## Product / Process Change Notification (PCN)

<b>PCN Number:</b> PCN_IndHEPC_20241015  <b>Affected Series:</b> WE-HEPC  <b>Affected Order Codes:</b> Please see table below  <b>PCN Date:</b> 2024-07-15 (YYYY-MM-DD) <b>Effective Date:</b> 2024-10-15 (YYYY-MM-DD)		<b>Change Category:</b> <input type="checkbox"/> Equipment/Location <input type="checkbox"/> General Data <input type="checkbox"/> Material <input type="checkbox"/> Process <input type="checkbox"/> Product Design <input checked="" type="checkbox"/> Shipping/Packaging <input type="checkbox"/> Supplier <input type="checkbox"/> Software		
<b>Contact:</b> Product Management <b>Phone:</b> +49 (0) 7942 - 945 5001 <b>Fax:</b> +49 (0) 7942 - 945 5179 <b>E-Mail:</b> pcn.eisos@we-online.com		<b>Datasheet Change:</b> <input checked="" type="checkbox"/> Yes <input type="checkbox"/> No  <b>Attachment:</b> <input type="checkbox"/> Yes <input checked="" type="checkbox"/> No		
<b>Description of Change:</b> Because of a database mismatch, Würth Elektronik eiSos, is updating the drawing specification by rotating the component 180° in the carrier tape. There will be no change in form, fit, function, quality or reliability of the product.

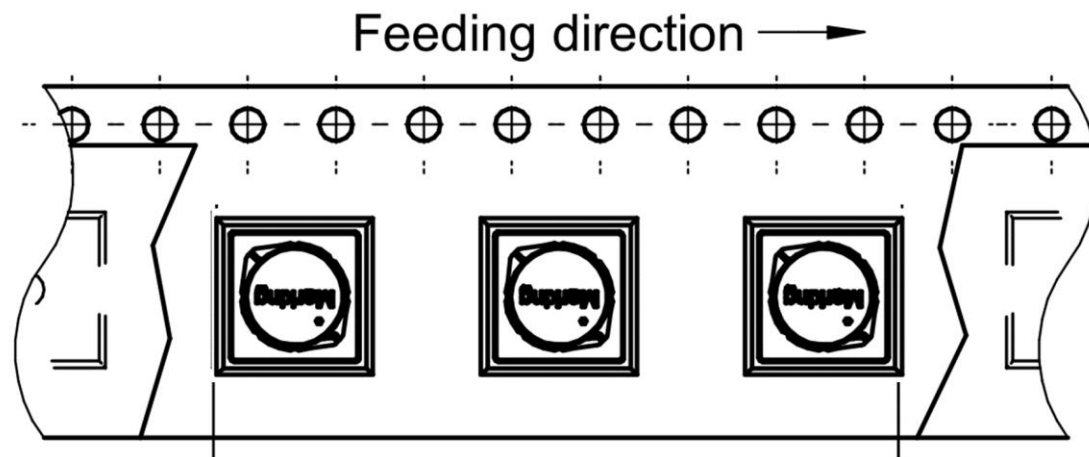
<b>Details of Change:</b>  Affected order codes:				
Size: 5030				
74408053003	74408053004	74408053006	74408053100	74408053150
74408053220	74408053330			
Size: 6030				
74408063004	74408063006	74408063100	74408063150	74408063220
74408063330	74408063470	74408063680	74408063101

Before Change:

After Change:
